RE: NECEC Conservation Plan – Opportunity for Comment

This letter provides public comment on the New England Clean Energy Connect (NECEC) Conservation Plan (“Plan”) submitted by NECEC Transmission LLC (“NECEC LLC”) to the Maine Department of Environmental Protection (DEP) on May 9, 2025. I present these comments as an experienced forest ecologist who has studied commercial forestry in Maine over the past three decades. Most of my studies have been done in partnership with commercial landowners, including Weyerhaeuser, the landowner involved in this easement. Before I offer my comments and analyses, I should be clear that I am a proponent of the corridor. To me, climate change is the primary threat to our children’s well-being, and to biodiversity, in the 21st century. We need clean energy, and we need those who have capital and wherewithal to make it happen.

Figure 1. Basal area (a) and tree heights (b) of different age-classes of forest, based on our studies of birds and LSOG forest in the unorganized townships of Maine, 2021-2024.^{1,2} Canopy heights are based on highly accurate LiDAR data. (n=463 plots)

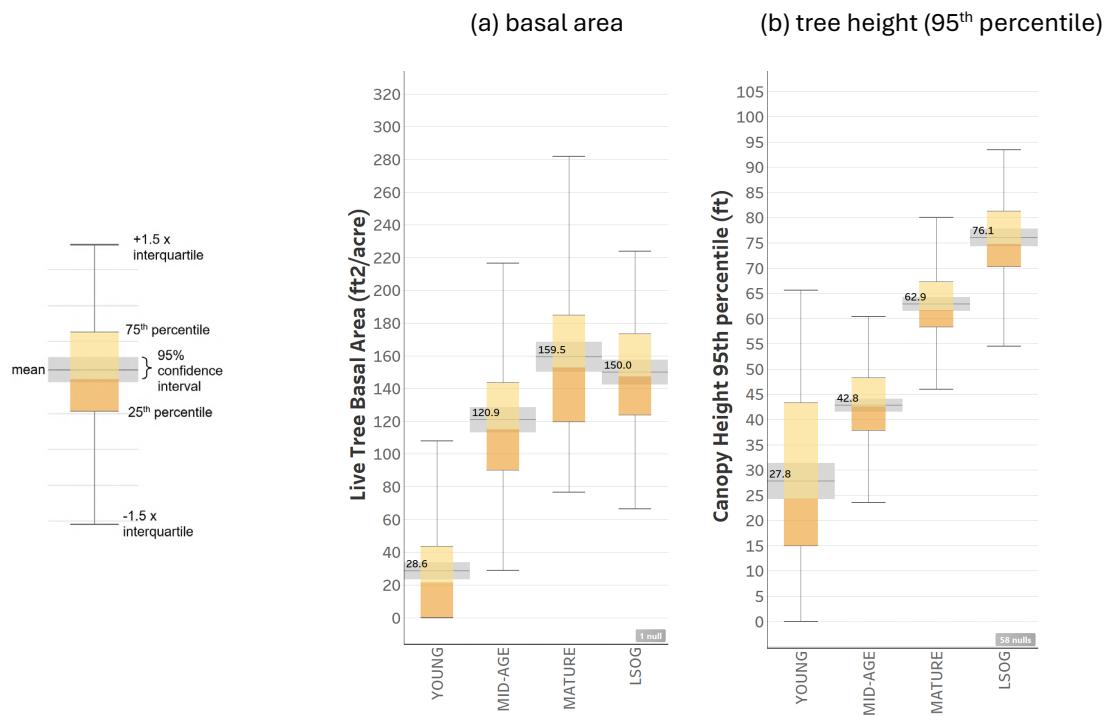
Having spent decades doing forest plot surveys in Maine’s commercial forest, the “mature forest” definition proposed in the Conservation Plan does not pass an ecological straight-face test. **If 60 ft²/acre of basal area with some trees at least 50 ft tall is the criterion Weyerhaeuser is willing to meet, then call it “partially-cut mid-age forest.” It is simply not “mature forest.”** The Conservation plan further loses credibility on page 4 where it states “... there is ample evidence in the record to support a threshold condition of those forest stands that achieve a minimum height of 35 feet.” Based on my field experience, mature forest would have a basal area of at least 120 ft²/acre and trees at least 60 ft tall (see Figure 1). The Conservation Plan further states on page 4 that the 60ft²/35’ criterion “supports wildlife,” as if *all* wildlife requires this specific condition. Indeed, the corridor, once built, with 0ft² basal area/acre, will provide habitat for many important early-successional bird species. But early-successional habitat is not limited in the transmission

- (1) consider including a moratorium on harvesting any remaining LSOG forest, regardless of whether it is in a 100' riparian buffer.
- (2) avoid the use of "mature forest" if the easement forest specifications are to remain set at 60ft²/acre of basal area and trees at least 50' tall, or come up with a definition that is ecologically credible with the broader scientific community.

Figure 2. LSOG map for proposed NECEC conservation easement. There is a total of 1,943 acres (787 ha) of LSOG forest in the proposed easement area.

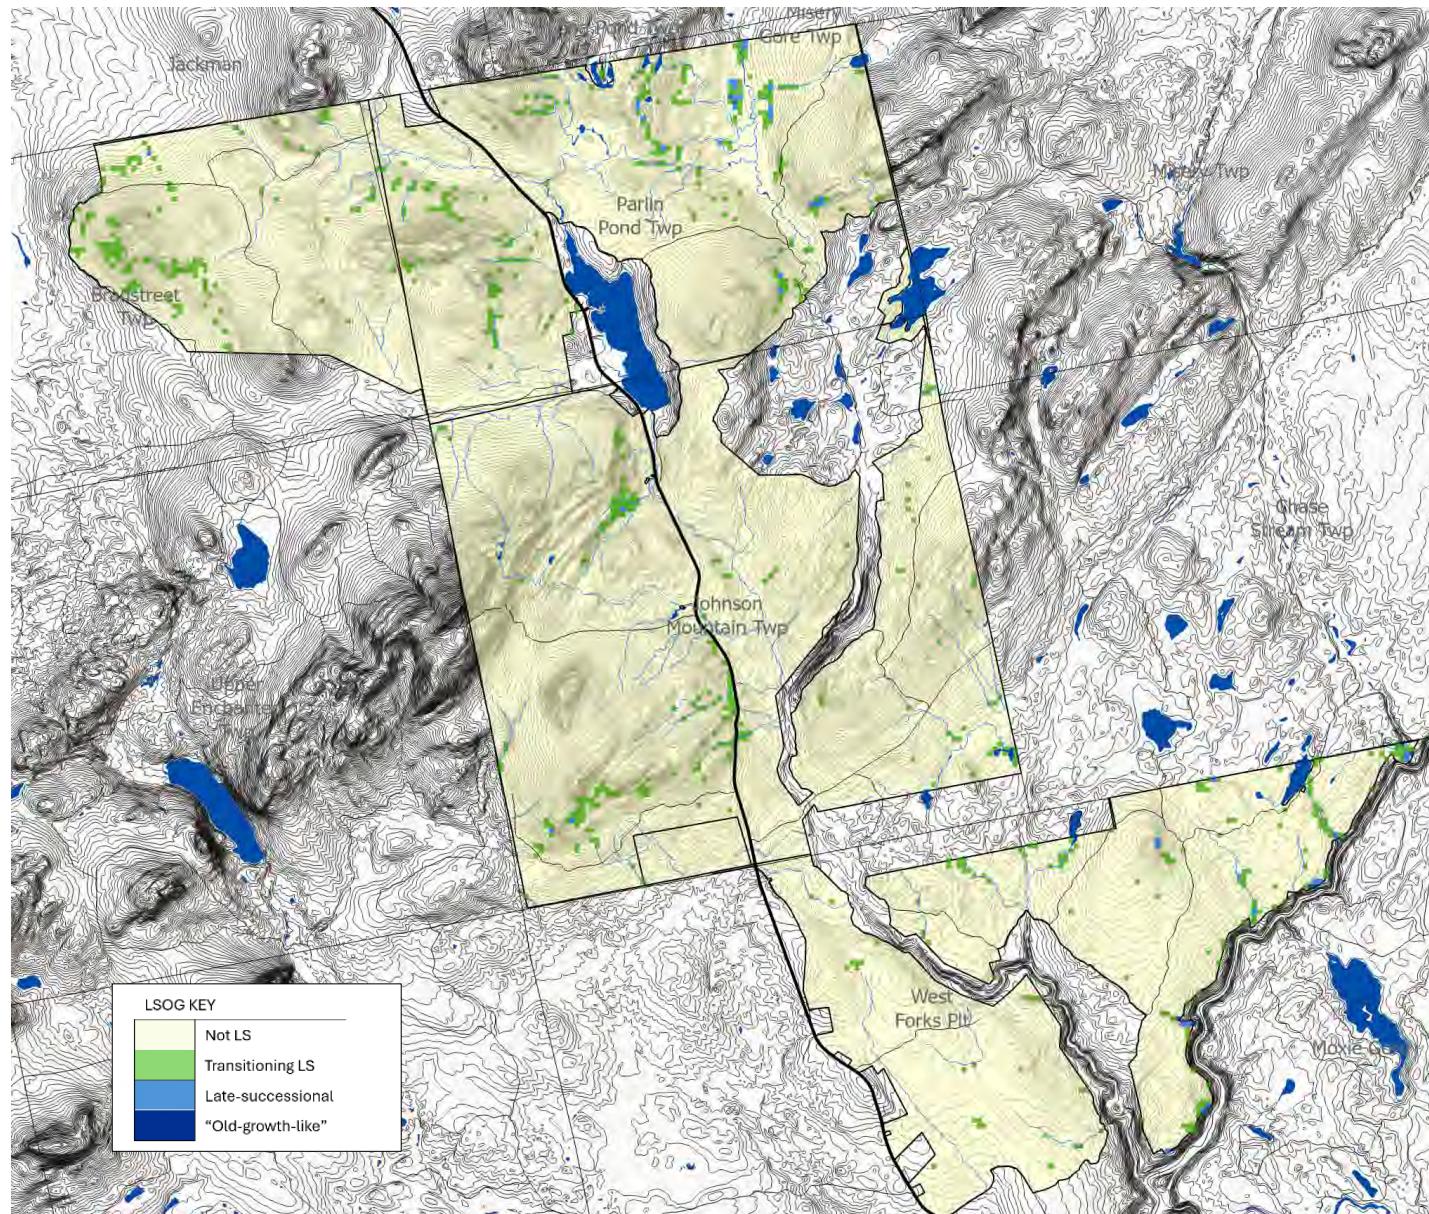
Figure 2 shows the current distribution of LSOG forest in the proposed easement. Even small 1-ha (2.47 ac) patches of LSOG forest can be ecologically significant. Many of the species most tightly associated with LSOG forest (lichens, mosses, liverworts) can persist for decades in small patches of LSOG forest. While these species do not need much area to survive, they do not disperse across the landscape very well. It can take them a long time (decades) to reach a nearby forest stand that grows into an LSOG condition. This is why these small patches of LSOG are so significant today. If we hope to restore these species to a larger area someday, these “lifeboats” of LSOG will be key. If biodiversity conservation is a goal of this easement, the easement developers could consider making these remnants of LSOG forest off limits to timber harvesting. Indeed, the landowners will need to be compensated for the forgone timber revenue, but the biodiversity benefit of the easement would be greatly increased.

Of the 1,944 acres of LSOG in the easement area, 240 acres fall within the proposed 100' stream buffers. This represents 12.34% of all the LSOG acres in the proposed easement. These 240 acres represent 9.1% of the 2,633 acres within 100' stream buffers.

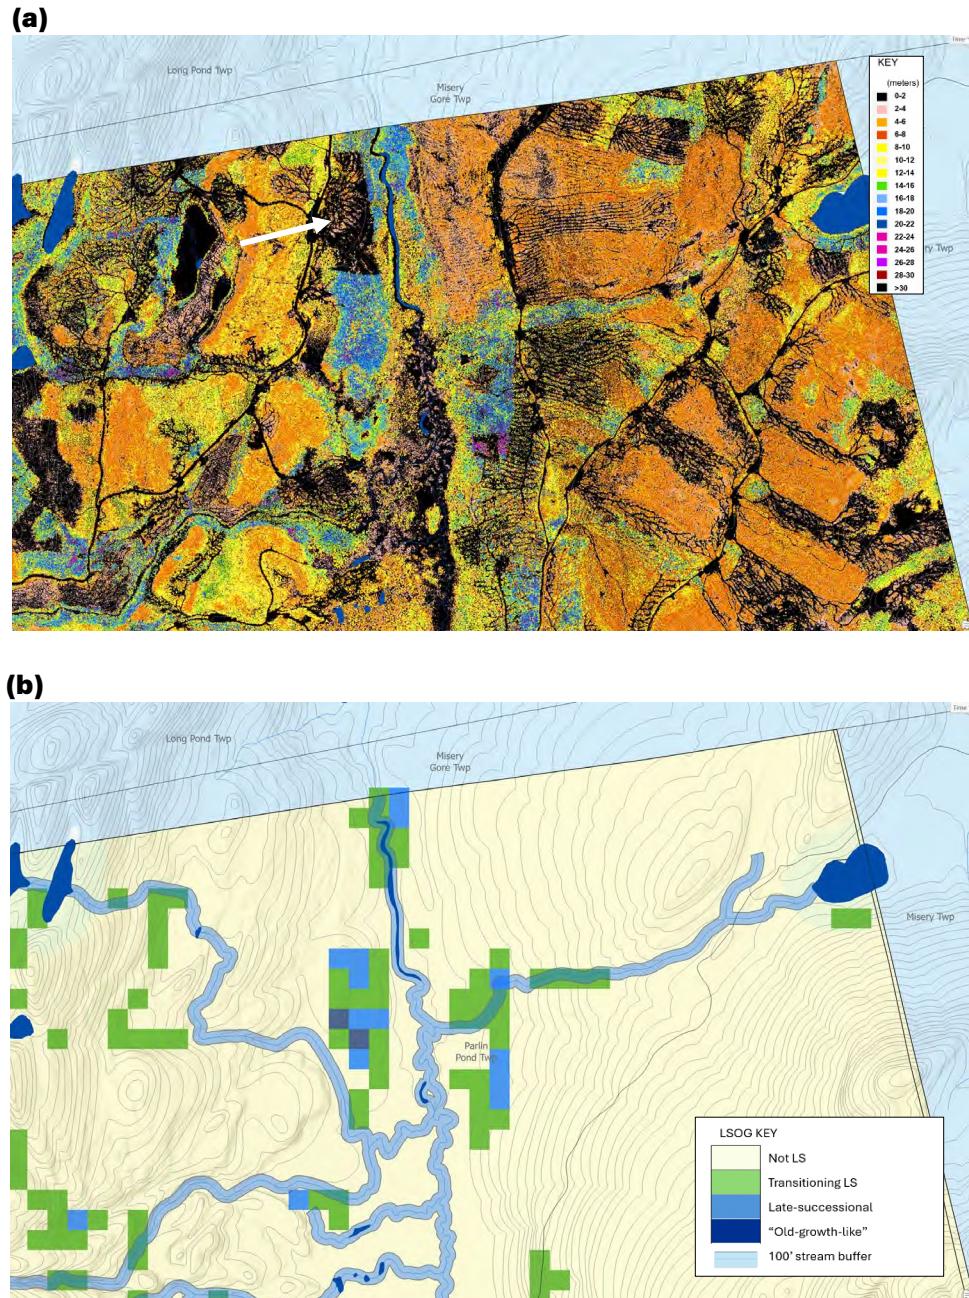
Figure 3 shows a closer look at a small LSOG stand in the northeastern corner of the proposed easement. Both the LiDAR-derived canopy height model (3a) and the LSOG classification are shown together (3b). Note the “blue-magenta” pixels in 3a. These are areas with trees 75-90’ tall, which classify as LSOG forest (see Hagan et al. 2024). The black areas are areas less than 6’ tall and tend to be roads, clearcuts, wetlands, or relatively recent skidder trails in a harvest block. Note that it looks like the northern half of an LSOG stand was recently harvested (see arrow in 3a). The easement instrument could incorporate the protection of such rare habitat.

The Conservation Plan also incorporates a 100’ no-harvest buffer along all streams (see Figure 3b). At least over time, these no-cut buffers will grow into LSOG forest. Some buffers already are LSOG forest (see close-up in 5b). In the easement area, there are 2,633 acres of forest in this designated 100’ buffer. Under the Conservation Plan, most all of these acres will become LSOG forest sometime in the future.

Figure 4. Harvest blocks (red) between 2001 and 2023 in the proposed easement and vicinity. Grid 1km². Data from Global Forest Watch. (<https://data.globalforestwatch.org/>). The initial clearing for the corridor is evident.

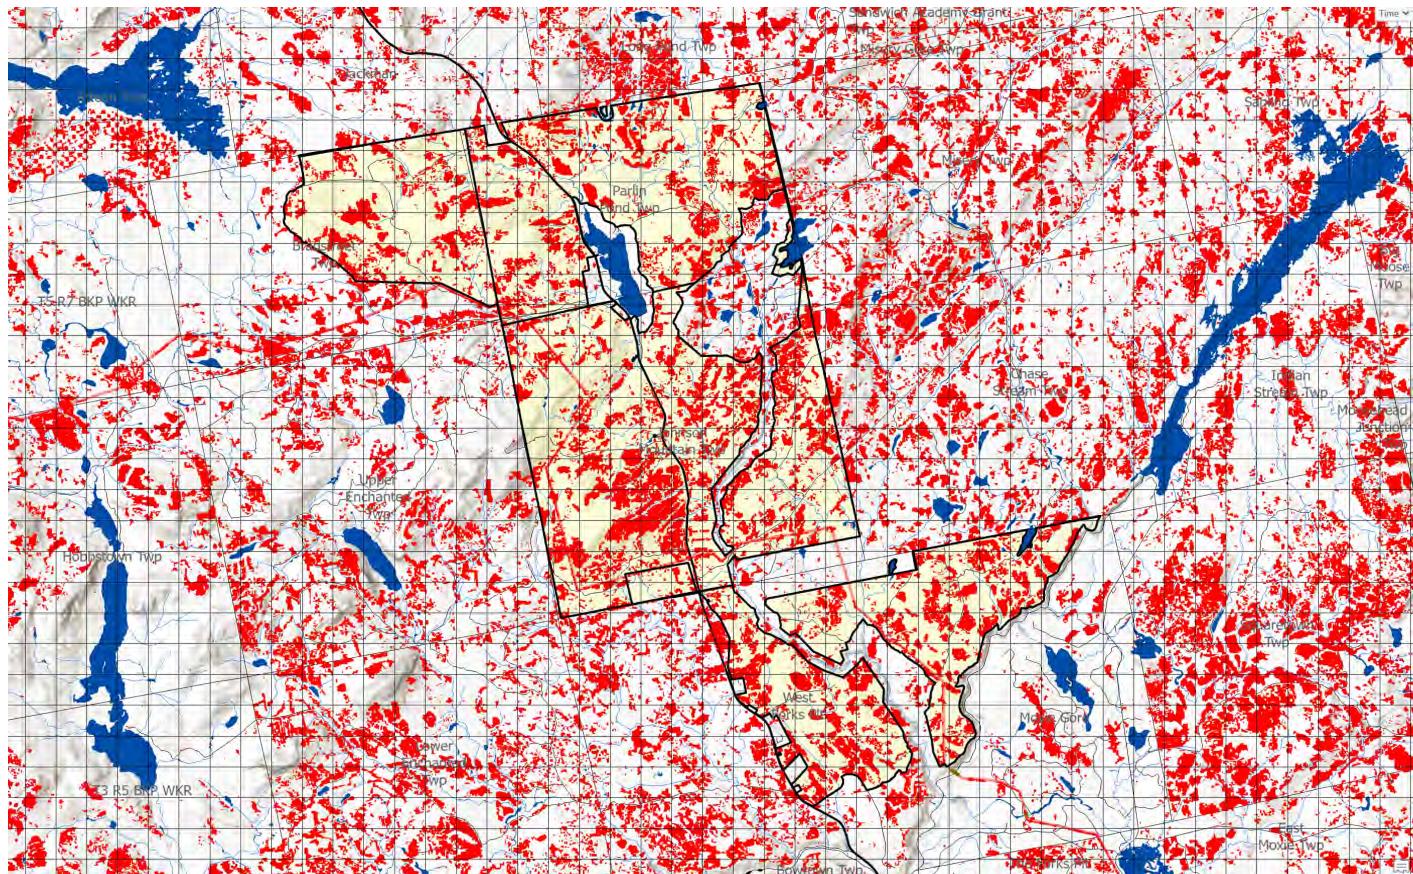
The proposed easement area has been one of the most intensively harvested areas of the unorganized township area of Maine in the last 20+ years (Figure 4.). This is not unexpected given that it is privately owned commercial forest and relatively close to mills.

Figure 5. Forest height of proposed easement area derived from growth-adjusted 2016 LiDAR data.

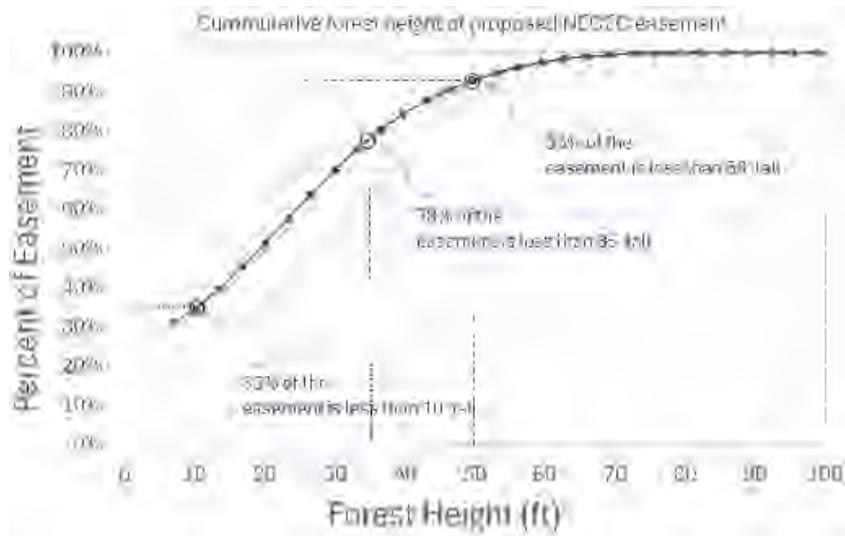
Because LiDAR data were obtained in 2016, I added 7 feet (2.13m) to all heights in the data layer, allowing for forest growth since then. I then derived the height distribution from the growth-adjusted canopy height data (Figure 5). This adjustment errs towards an overestimate of current height because the 2016 LiDAR does not include harvested areas since that time, which would result in a reduction in height.

I found a discrepancy between the height of the forest reported in the Conservation Plan and LiDAR-derived heights. The Conservation Plan states that 40% of the easement area is greater than 35' tall. By contrast, growth-adjusted LiDAR data indicate that only 22% of the forest greater than 35' tall (Figure 5). The difference is probably methodological. Foresters might classify an entire stand as 35', even if just some of the trees are 35'. LiDAR classifies the height of every square meter in a stand, whereas a forester might assign a maximum height to a whole stand, irrespective of any canopy gaps resulting from prior harvesting. A second common stand descriptor called canopy closure is used by foresters to describe stocking level (A=closed canopy, D=very open canopy, such as a recent shelterwood harvest). While the differences between my analysis of canopy height and the Conservation Plan's analysis may be methodological, it is still good to know the *true* height of the entire landbase with the 1-m² precision provided by LiDAR data.

Probably for the same reasons, my estimate of the amount of forest greater than 50' tall also differed from the Conservation Plan. I found 7% of the area of interest greater than 50' tall. The Conservation Plan reports 13%.
